APPLICATION NO.	FILING DATE	FIRST NAMED INVENTOR	ATTORNEY DOCKET NO.	CONFIRMATION NO.
09/881,909	06/15/2001	Richard Wisniewski	17882-746	8189

Office Action Summary

Applicants response of September 22, 2003 (Paper No. 14) further amends claims 1 and 30. Applicants have elected Figures 1 and ~~2~~. Applicants have elected Figures 1 and 2 and have asserted all of claims 1-55 read on the elected species in Paper No. 12 (amendment of May 12, 2003). In Paper Nos. 12 and 14, no additional illuminating disclosure of the prior art discussed in the specification other than what is discussed by Mr. Wisniewski in paragraphs 7 and 9 of the second declaration received May 12, 2003. Counsel should note that the first declaration of Mr. Wisniewski referenced in the second declaration by Mr. Wisniewski is not of record here and hence has not, officially been considered here. In order to expedite prosecution, however, the Examiner already has a copy of the first declaration in SN 10/057,610 and the critique of both the first and second declarations from that application are reproduced below. Evidentiary materials referred to in these critiques can be found in SN 10/057,610 or at the Integrated Bio

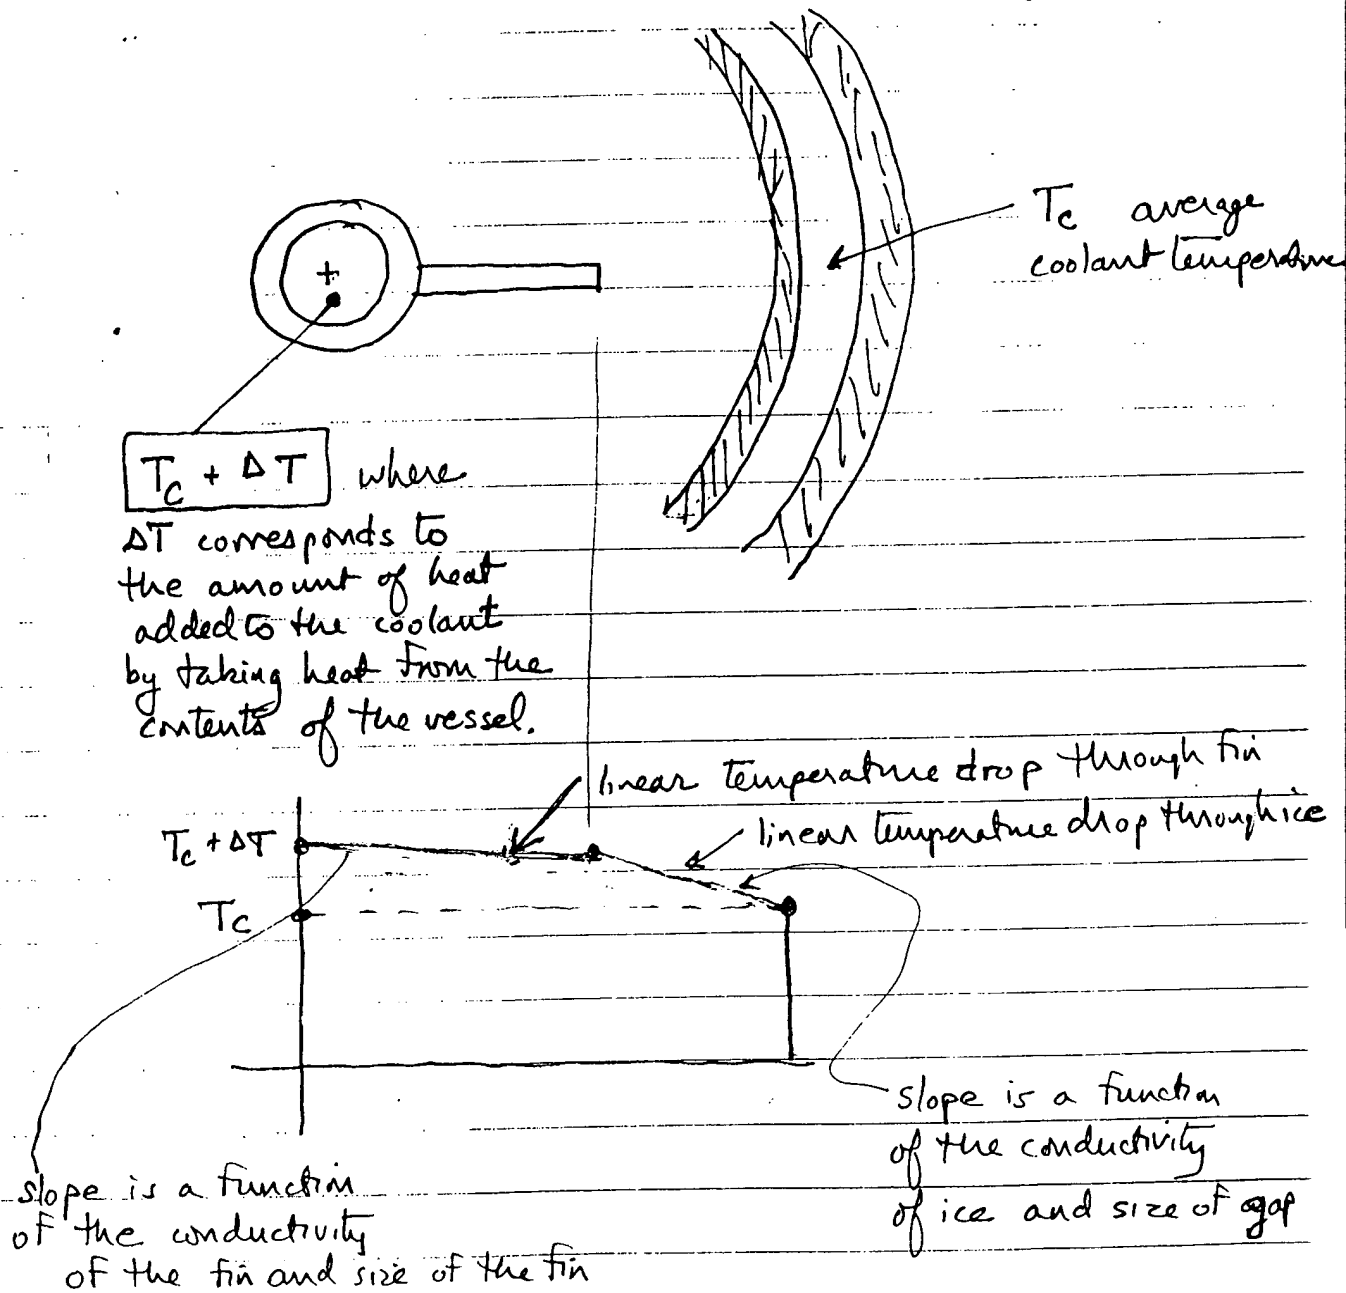
Moreover, Exhibit B incorrectly assumes the temperature in the pipe is the same as the temperature in the jacket. This is an incorrect assumption and will necessarily lead to inaccurate conclusions. The temperature in the pipe is a complex function of the initial temperature of the coolant before it passes through the jacket, the temperature of the liquid in the container and the flow rate of the coolant among other variables. As explained above, and as shown in Figure 1 (page 134) of the 1992 article, the coolant goes from the refrigeration system to the jacket and only after exchanging heat with the contents of the vessel (and thereby acquiring some higher temperature) does it pass into the central structure where it necessarily must have a higher temperature than the

coolant in the jacket. Thus, Mr. Wisniewski's thought experiments are flawed because they are based on incorrect boundary conditions.

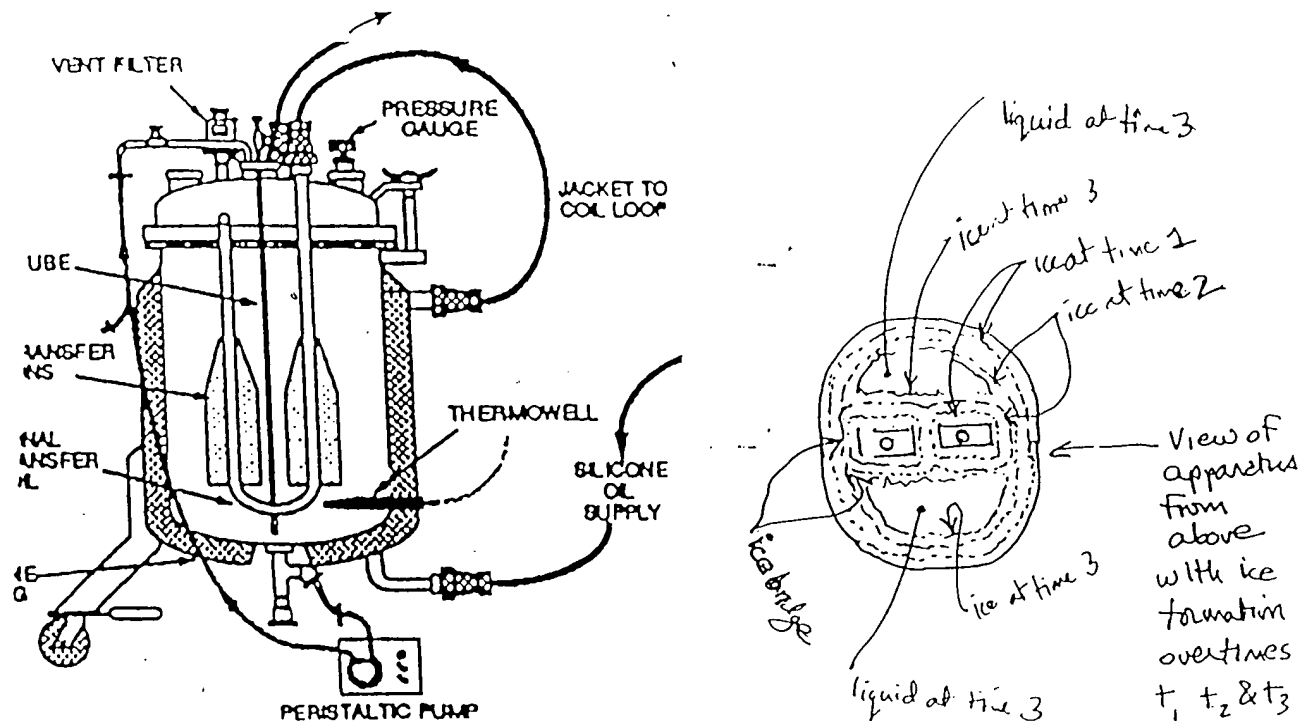
The thermal bridge of ice will inherently form between the tip of the heat transfer fins and the interior of the container because they are the closest points to one another and both are actively cooled by circulating cooled silicon oil. Closely spaced cooled surfaces are known by those of skill in the refrigeration art to form ice bridges when a liquid is being frozen into a solid.

As evidence to support the Examiner’s statement the closely spaced cooled surfaces will inherently form ice bridges (see MPEP 2112-2112.02, dealing with inherency, incorporated here by reference), the reader is referred to Voorhees USP 983,466 page 1, col. 2, line 97 – page 2, col. 1, line 5 (Voorhees is not relied upon explicitly here, see MPEP 2131.01, sub-section III), wherein it states:

It is evident that ice will build upon the heat exchanger and walls of the vessel shown in Figure 1 of 1992 Wisniewski and Wu research paper, during the freezing phase, until they bridge as shown in the diagrams below, a fact that can be established by basic scientific principles. Burroughs et al. USP 3,318,105 illustrates the phenomena. As is clearly seen in Figs. 1A-1C ice builds up evenly cooled surfaces and even as the top surface freezes the ice coating on the submerged surfaces continues to build up more or less evenly. The same type of analysis is disclosed by Finnegan USP 2,129,572, illustrating that the time required to freeze a substance varies "approximately as the square of the thickness of such substance" with slower freezing generally leading to undesirable concentration effects (what applicants and the 1992 Wisniewski and Wu research paper refer to as "cryoconcentration"). Finnegan, like the 1992 Wisniewski and Wu research paper, discloses the use of heat exchange fins (projecting inwardly from the exterior wall of the container in the case of Finnegan) to form compartments within the tank to speed the freezing process. Finnegan illustrates using a series of dotted lines how the freezing process progresses over time in various geometries of

heat exchange fins. Applying this same science (illustrated by Burroughs and Finnegan) to the system disclosed by 1992 Wisniewski and Wu research paper yield the results illustrated on the next page for the system disclosed by the 1992 Wisniewski and Wu research paper in Figure 1.
